FLIGHT DESIGN

Flight Design Manufacturer Approval

for CTSW, S/N: 06-10-04

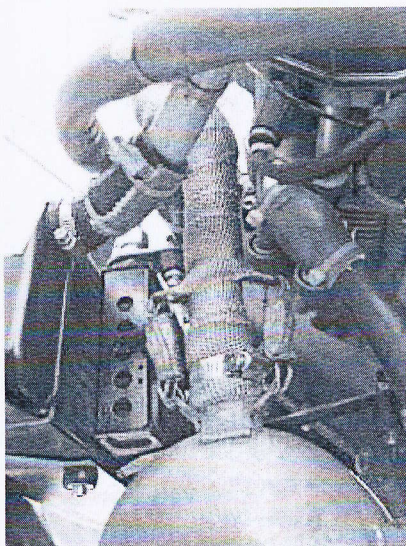
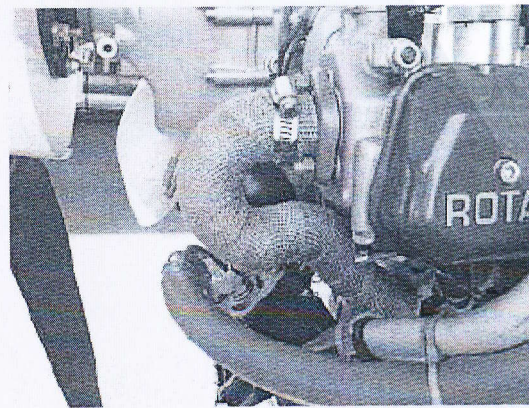
We approve installation of the 2" Thermo-Tec header wrap, based on the photos below. The wrap of the exhaust pipes reduces accessibility to inspection for cracks on the exhaust pipe. Such cracks may lead to exhaust fumes coming into the cabin. Therefore it is in the obligation of the owner / modifier to ensure that the exhaust pipes are inspected for condition at the intervals defined for this aircraft, regardless of the reduced accessibility.

Note: Approval is given for the mechanical installation only. Correct function of all installed equipment is under the obligation of the modifier as this can not be checked by Flight Design.
